# UNITED STATES PATENT AND TRADEMARK OFFICE

APPLICATION NO.	FILING DATE	FIRST NAMED INVENTOR	ATTORNEY DOCKET NO.	CONFIRMATION NO.
10/642,708	08/18/2003	Jason Werning	35650	4369
116	7590	07/13/2007		
PEARNE & GORDON LLP 1801 EAST 9TH STREET SUITE 1200 CLEVELAND, OH 44114-3108			EXAMINER GLUCHOWSKI, KRISTINA R	
			ART UNIT 3676	PAPER NUMBER
			MAIL DATE 07/13/2007	DELIVERY MODE PAPER

<b>Office Action Summary</b>	<b>Application No.</b> 10/642,708	<b>Applicant(s)</b> WERNING, JASON	
	<b>Examiner</b> Kristina R. Gluchowski	<b>Art Unit</b> 3676

## **DETAILED ACTION**

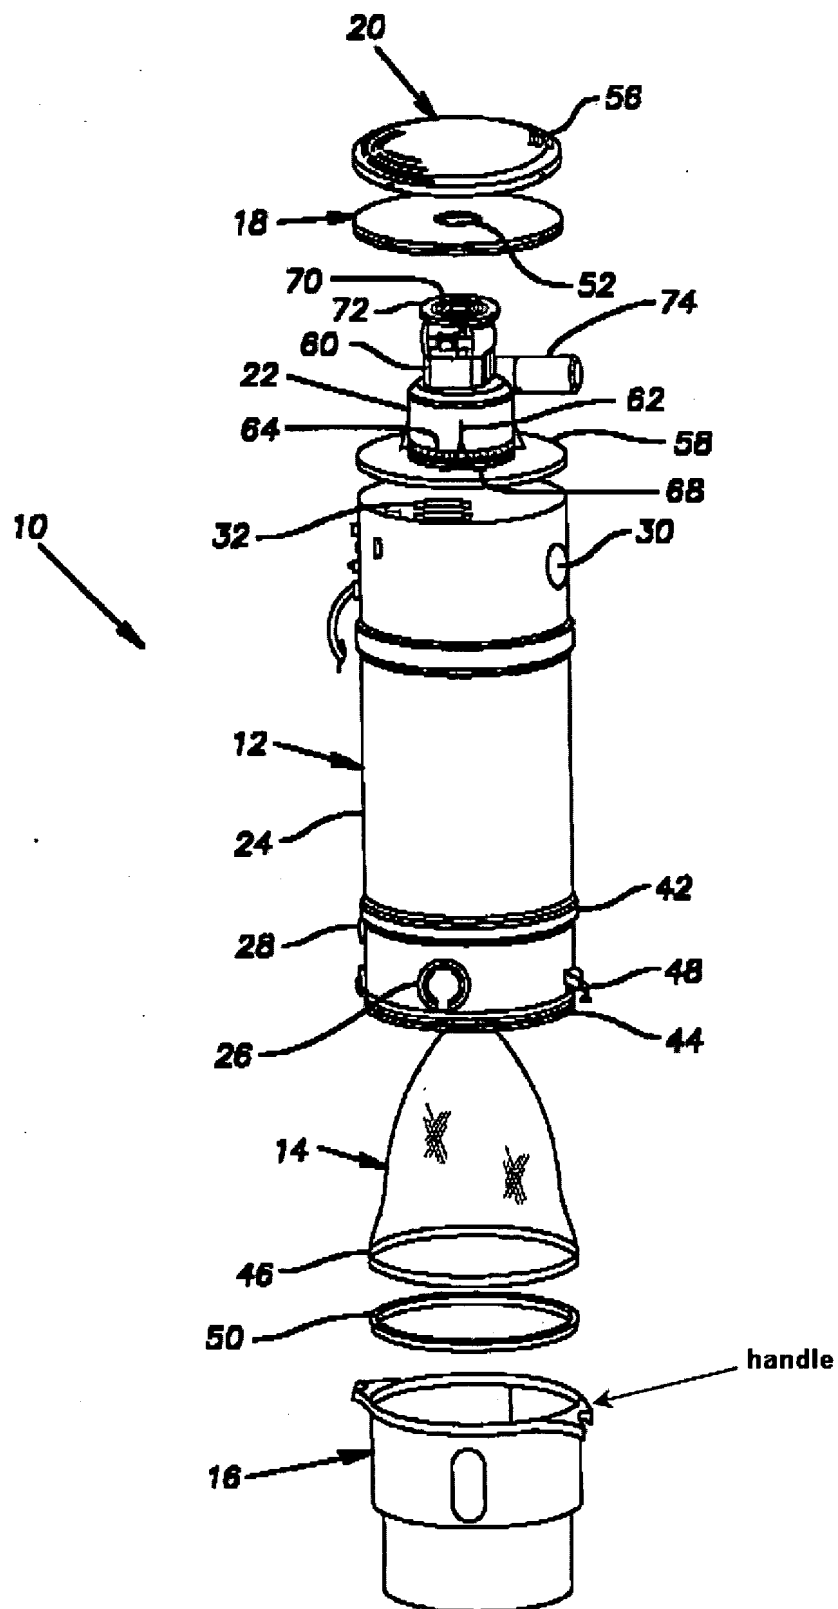
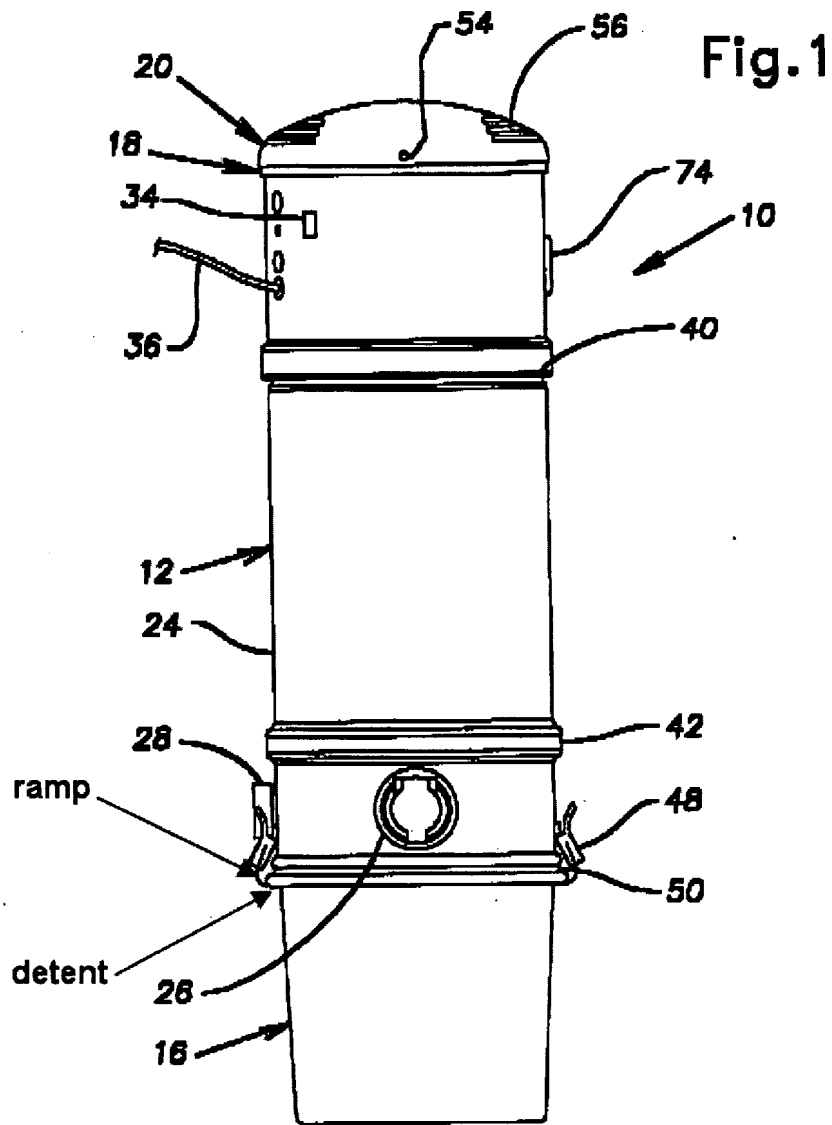
3. Regarding claims 1, 19, 21, 23, Fritz shows a locking mechanism for a central vacuum system with a debris receptacle (16) and a canister (12), the locking mechanism comprising a vertical gasket (50) to facilitate an airtight seal between the debris receptacle and the canister of the central vacuum system and a twist-lock latch (48) configured to guide a handle (see illustration below) portion of the debris receptacle to a lock position (the attached position is considered a lock position; see column 3, lines 25-30) between the twist-lock latch and the vertical gasket (see figure 1, the handle portion is between gasket 50 and bottom portion of latch 48). The examiner would like to note that a "twist-lock latch" could be any latch. The term "twist-lock" is considered a label in claim 1 since no further structure of the twist lock latch is claimed.

4. Regarding claims 2 and 24, the latch comprises a contoured ramp (curved guide portion of latch, see illustration below) "configured to" guide the handle portion of the debris receptacle to the lock position.

5. Regarding claim 3, the latch comprises a stop detent (hook portion on bottom to engage handle, see illustration below) to fully engage the debris receptacle into the lock position.

6. Regarding claim 8, the vertical gasket includes a bead roll (see illustration below; lower portion of gasket), configured to be received by a groove (44) formed in an exterior surface of the canister (column 3, lines 30-32).

7. Regarding claim 20, Fritz shows two latches (48) on opposing sides of the canister (see figure 1). See the Fritz device below.

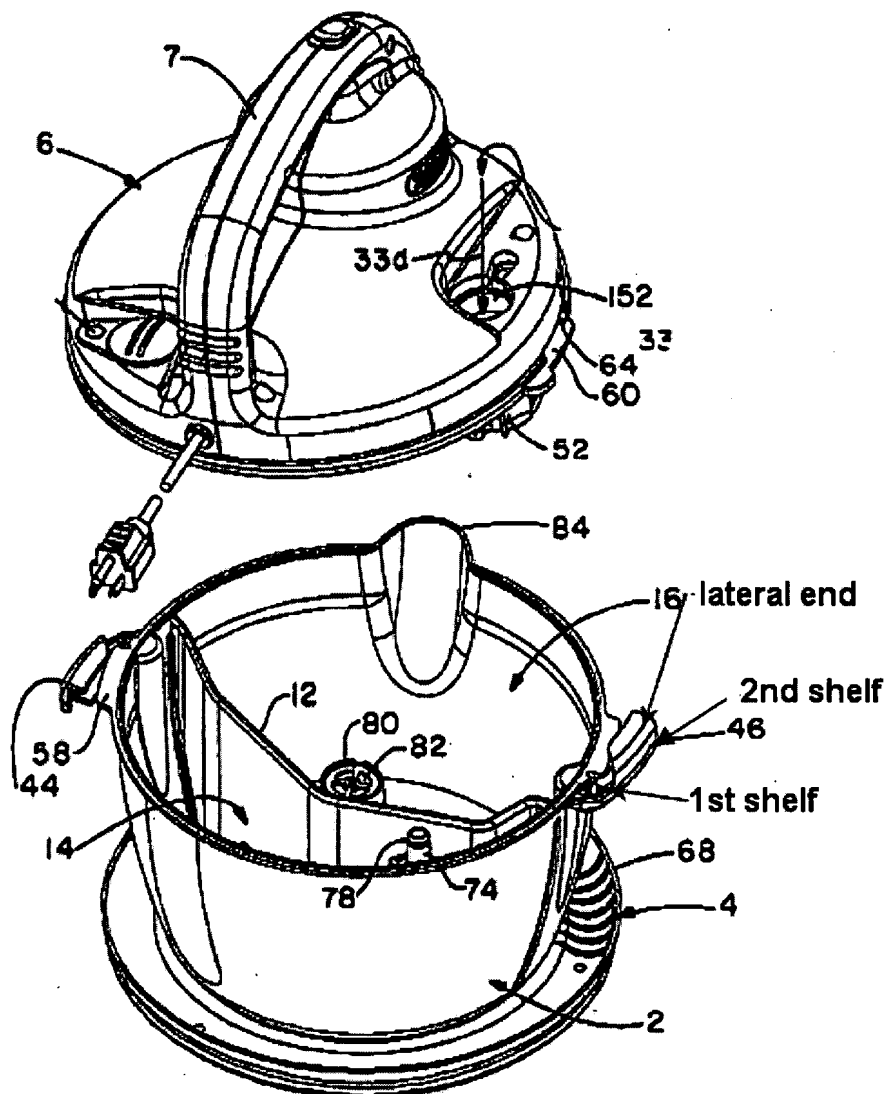
11. Regarding claims 9, 22 and 25-28, Fritz shows a canister and receptacle with a handle portion and latch as applied to claim 1 above. Crouser shows a latch attaching the debris receptacle (2) to the upper portion (6) wherein the latch has a first shelf portion (see illustration below) and an open lateral end portion (see illustration below) "configured to" laterally receive the handle portion of the debris receptacle from a portion outside the canister and a stop detent (handle hits round portion of latch; see figure 3) to facilitate proper engagement of the handle portion in the lock position.

12. Regarding claim 10, Fritz in view of Crouser, Crouser shows a second shelf portion (see illustration below). It would have been obvious to one of ordinary skill in the

13. Regarding claim 11, Fritz in view of Crouser, Crouser shows a contoured ramp (54) "configured to" guide the handle portion of the debris receptacle into place.

14. Regarding claim 12, Fritz in view of Crouser, Crouser shows the latch is "configured to" be coupled to the canister portion of the central vacuum system via a fastener (post 40).

15. Regarding claim 13, Fritz in view of Crouser, Crouser shows a latch with no moving parts. The latch as a whole rotates but the latch itself does not contain moving parts as claimed.

16. Regarding claims 9-13, 22 and 25-28, it would have been obvious to one of ordinary skill in the art at the time of applicant's invention to replace the latch of Fritz with the latch of Crouser since replacing one latching means for another is considered to be within the level of ordinary skill of a worker in the art. Both latching means accomplish sealing a a receptacle to a top portion (canister). Replacing the Fritz latch with the Crouser latch would increase ease of use for the device in that the latching and unlatching motion would be reduced to a simple rotation as opposed to holding the canister in place and snapping each latch separately. See the Crouser device below.
